6-November-2020

RE: Response to Technical Evaluation Comments and Information Request
#3 for Underground Injection Control (UIC) Permit Application Class VI
Pre-Construction Permit Application No. R9UIC-CA6-FY20-1

Figure 6. Rock types along the E-W cross section (from Petrel 2019).

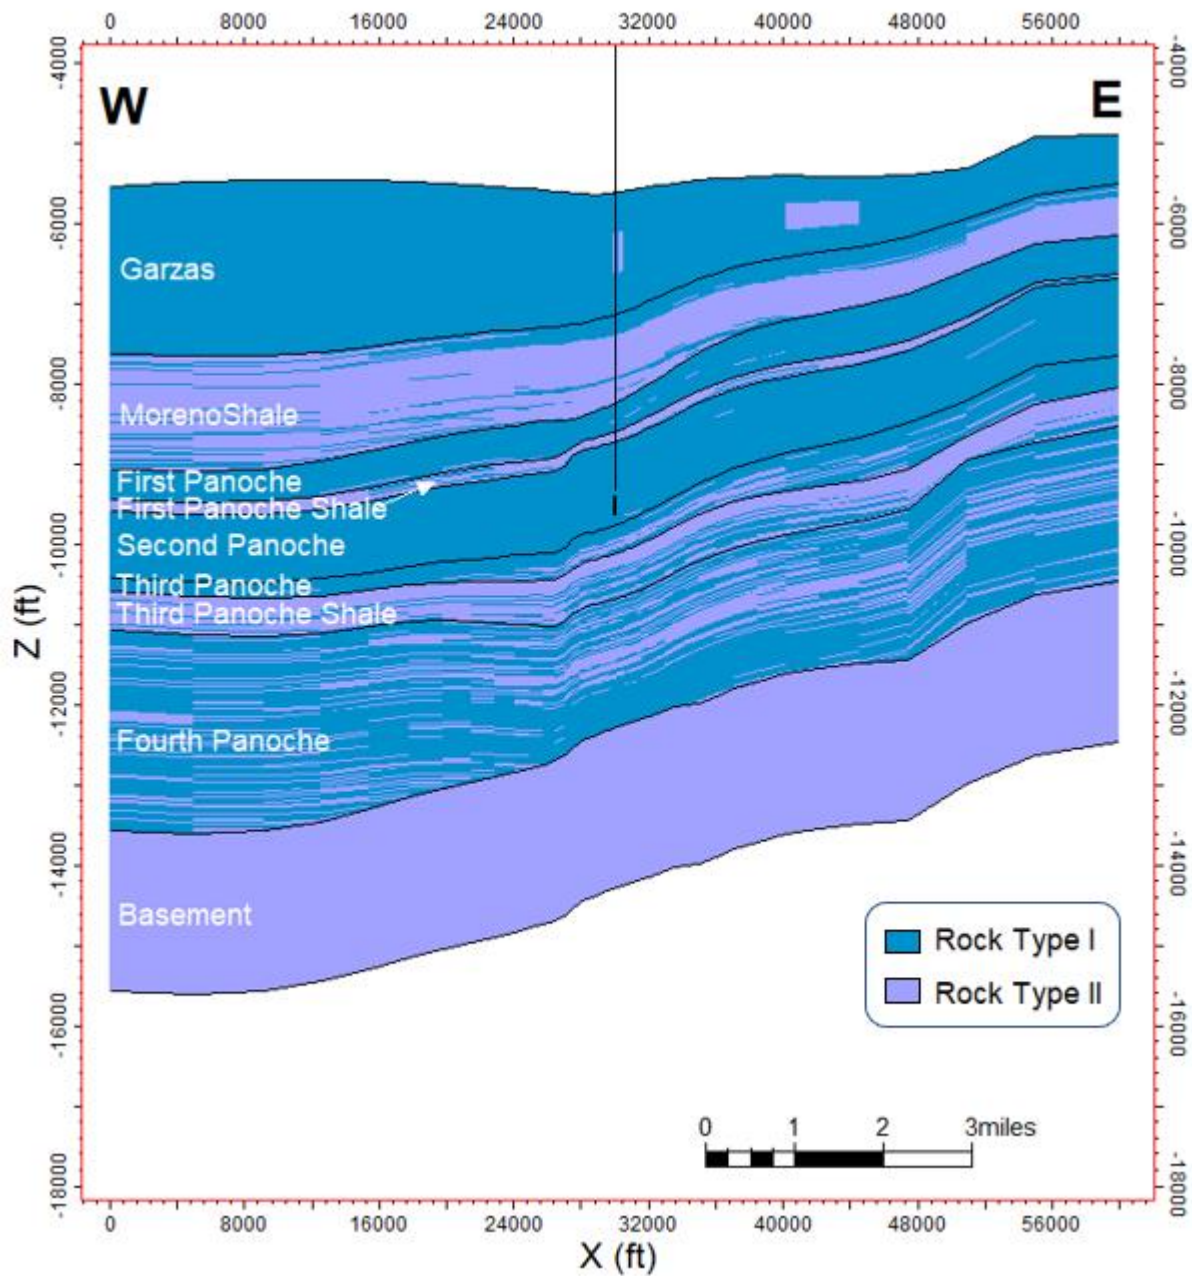
Figure 2 in the Rock Types file shows rock types along an E-W cross section. The cross section has two different shades of blue in addition to purple.

- Is there a difference between the two shades of blue in Figure 2 of the Rock Types file?
 - *No, the different blue shades are due to the presence of grid lines shown on the figure. Refer to Figure 6 in Appendix A for an updated version.*
- Please label the formations in Figure 2.
 - *Refer to Figure 6 for an updated version of Figure 2 in Appendix A which includes the formation names.*

- *The facies model described in Figure 30 (updated with Figure 5) was a preliminary estimate to perform fault seal analysis. This facies log was not used as part of the petrophysical model interpolation. The rock classification methodology (neural network) was used to create the hydrofacies interpretation needed for dynamic modeling. Porosity and permeability of the geocellular model were upscaled to a tartan grid used for dynamic modeling. Please refer to Figure 6 in Appendix A.*

Figure 7. Upscaled porosity profile along the N-S cross-section.

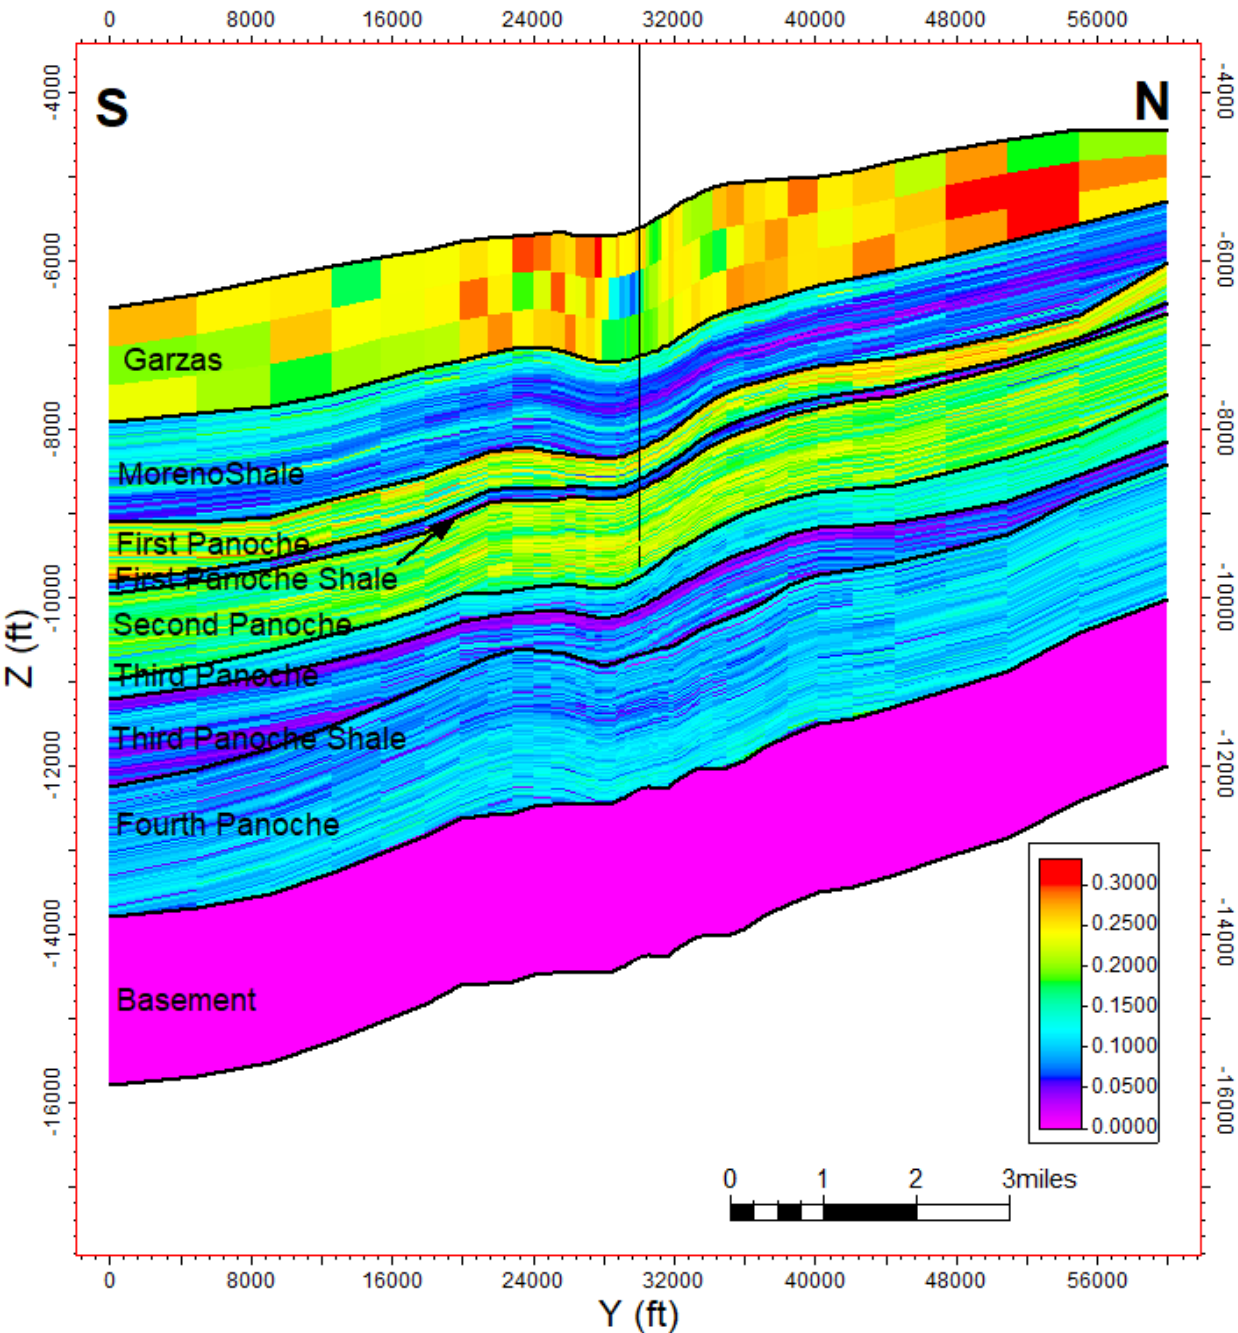
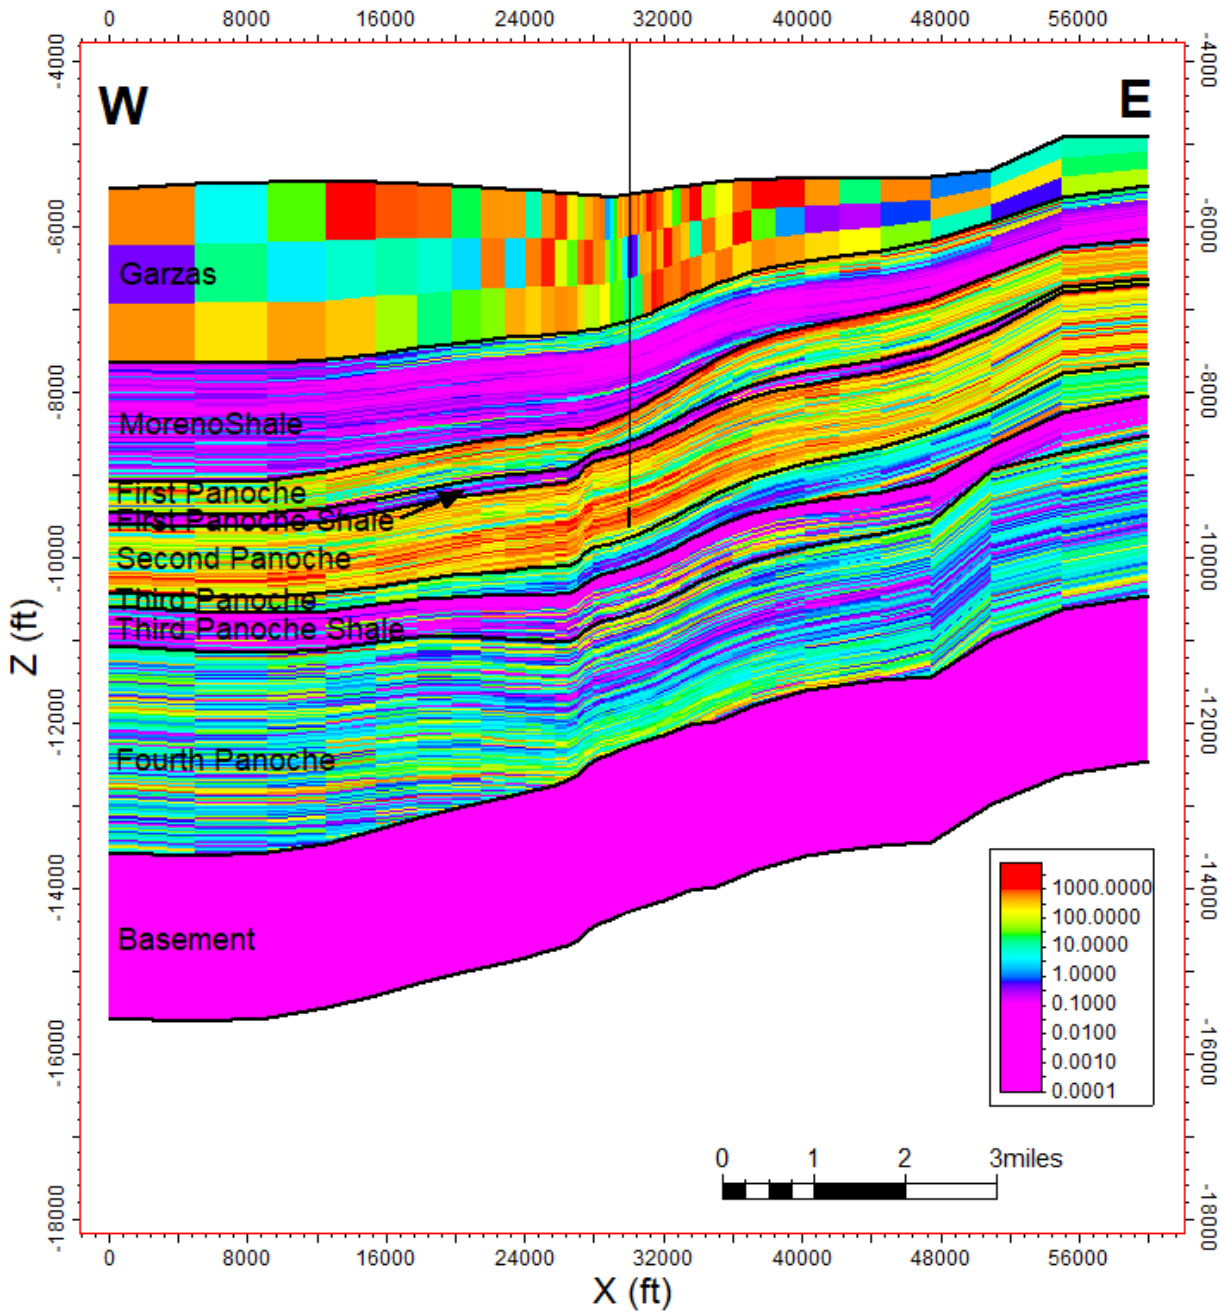
2.3.1	"The upscaled porosity and permeability graphics in Attachment B (Figures 3 and 4) would benefit from labeling for formation tops."	<i>The figures were updated with formation tops in Figure 7 and Figure 8 (refer to Appendix A).</i>
